ISSUE: Permit to Demolish/Capsulate (partial) and Certificate of Appropriateness for an addition and alterations

APPLICANT: Martha Peterson

LOCATION: Old and Historic Alexandria District
111 Prince Street

PETERSON RESIDENCE RENOVATION

Figure 1: Scope of demolition

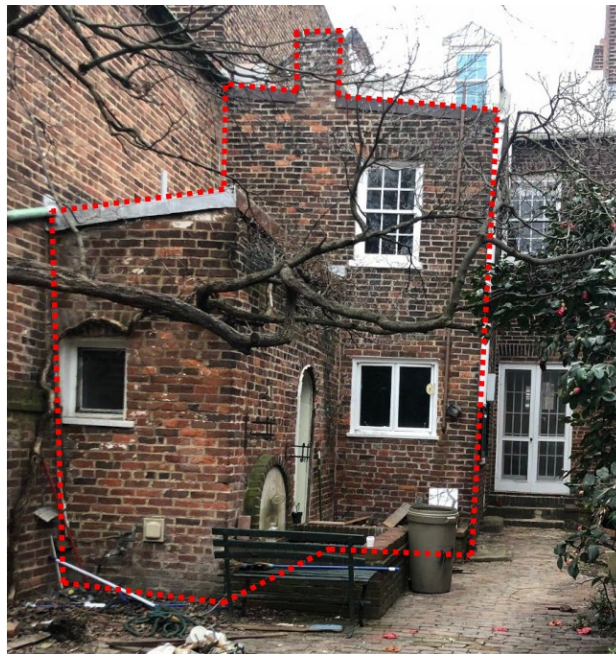
In the opinion of staff, none of the criteria for demolition and capsulation for the existing one-story addition, exterior wall of the ell, and two new windows are met and the Permit to Demolish/Capsulate should be granted. The one-story addition at the north end of the building does not appear to have been built at the same time as the rear ell and its existing condition is such that the bricks have been damaged and multiple utilities have been applied to the existing walls. This minor portion of the building is minimally visible from the public alley because of the location of existing fences, its removal would not be a detriment to the public interest or deter from the historic character of the building. The north wall of the existing ell includes an existing chimney and two existing windows, one of which has been modified from the original. See Figure 1 for the scope of the proposed demolition. This wall is not of unusual or uncommon design as this is a typical building condition for the historic district. Staff, therefore, does not object to the demolition/capsulation of the afore-mentioned features.

Figure 2: Proposed side elevation

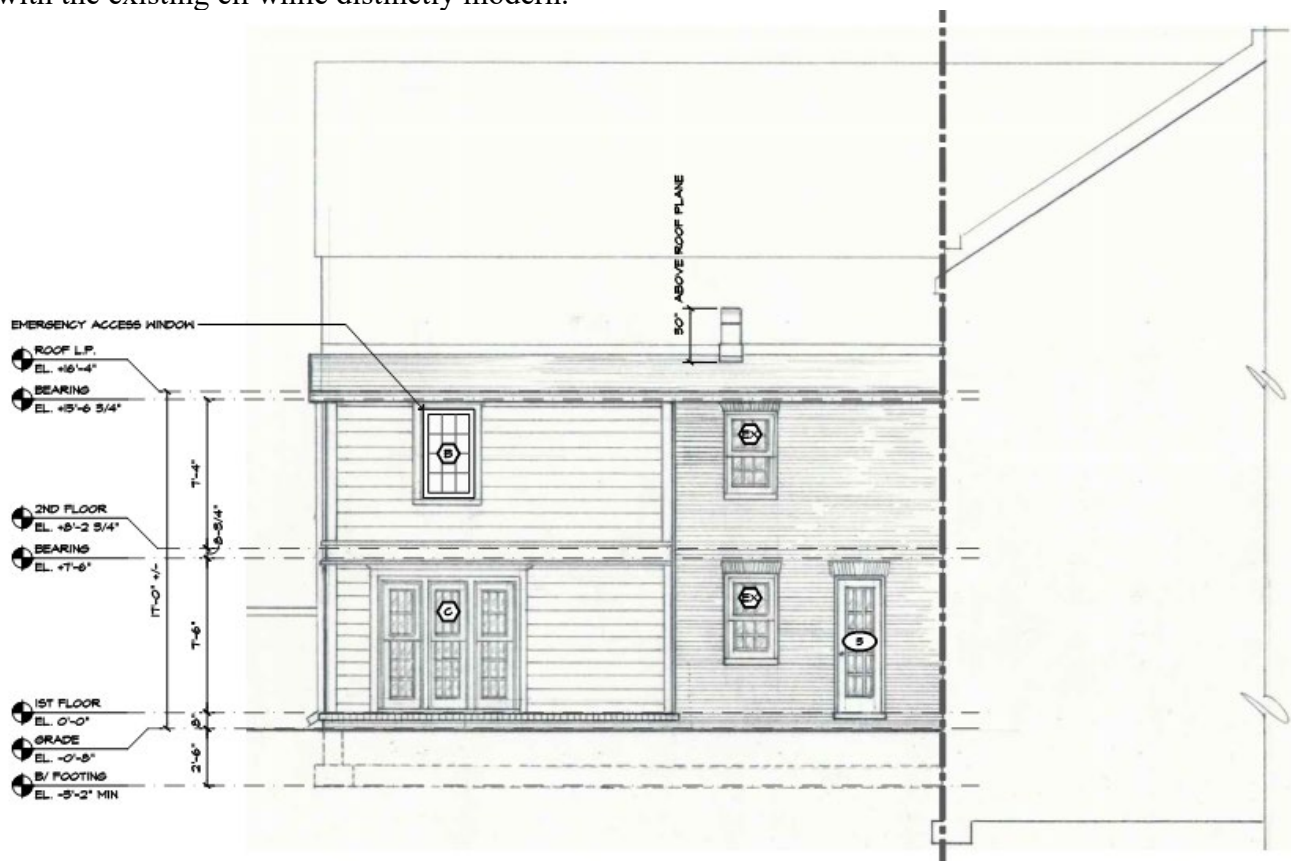
According to the *Design Guidelines*, “An addition to a historic building should be clearly distinguishable from the original structure. An addition should not obscure or dilute the architectural and historic importance of an existing building by creating a false sense of the past. To create a differentiation between the existing building and an addition, different traditional materials can be utilized.”

The addition at 111 Prince Street will do just that. Using Hardie Panel exterior cladding clearly distinguishes the addition from the original brick construction. The continuity of the existing roof slope and building form into the proposed addition makes for an addition that is clearly compatible with the existing ell while distinctly modern.

Staff supports the proposed Permit to Demolish/Capsulate (partial) and Certificate of Appropriateness for the proposed work at 111 Prince Street with the condition that the existing front door be either repaired or replaced to match the existing in dimension and style. Staff notes the recommendations of Alexandria Archaeology.
